Access Compliance Report Public Rights-of-Way (Curb Ramps)

Intersection ID: 14980	Main Street: DILWORTH RD EAST	Cross Street: EAST BV	Location: E
ADA ID: B8E00538CC17	Ramp Type: Perp	Initial Pass/Fail: Pass	Overall Compliance: No Severity Score: 10

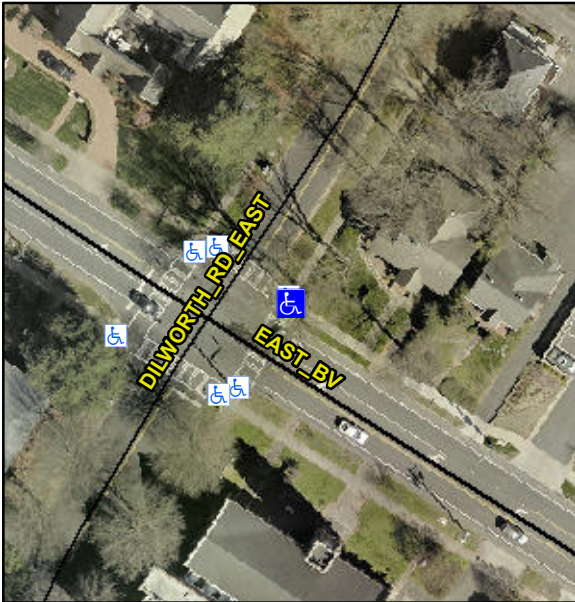
Not Found, R304.2.2-Perp, R304.3.2-Para, R305

Compliance	Description	Data	Compliance	Description	Data
N/A	Ramp Length (in)	48.0	Yes	Ramp Slope (%)	6.0
Yes	Ramp Width (in)	67.0	Yes	Ramp XSlope (%)	1.1
N/A	Flare Type LT	Sloped	N/A	Flare Type RT	N/A
N/A	Flare Slope LT (%)	5.6	N/A	Flare Slope RT (%)	3.9
N/A	Flare Traversable LT?	Yes	N/A	Flare Traversable RT?	No
Yes	Landing Length (in)	76.0	No	DWS Provided?	No
Yes	Landing Width (in)	67.0	N/A	DWS Contrast?	No
No	Landing Slope (%)	4.0	N/A	DWS Length (in)	N/A
Yes	Landing X Slope (%)	1.2	N/A	DWS Full Width?	No
N/A	Landing Curb? (Y/N)	No	N/A	DWS Offset (in)	N/A
N/A	Shared Landing?	Yes			
Yes	Gutter Ponding?	No	Yes	Gutter Slope (%)	2.6
Yes	Gutter Lip Ht (in)	0.0	Yes	Gutter X Slope (%)	0.7
N/A	Painted X Walk1?	Yes	N/A	Painted X Walk2?	N/A
	X Walk 1 Direction	To SW		X Walk 2 Direction	N/A
N/A	X Walk 1 Width (in)	112.0	N/A	X Walk 2 Width (in)	N/A
	X Walk 1 Slope (%)	2.2		X Walk 2 Slope (%)	N/A
	X Walk 1 X Slope (%)	1.7		X Walk 2 X Slope (%)	N/A

Yes	Ramp inside XWalk1?	Yes	N/A	Ramp inside XWalk2?	N/A
	Road Slope (%)	N/A	N/A	Clear Space?	Yes
	Road X Slope (%)	N/A	N/A	Clear Space to XWalk (in)	N/A
Yes	Any Obstructions?	No	Yes	Storm Grate/Utility Hazard?	No
	Obstruction Type			Storm Grate/Utility Type	
			N/A		N/A
			Yes	Surface Condition? (G/P)	Good

Remove & Replace Entire Ramp.
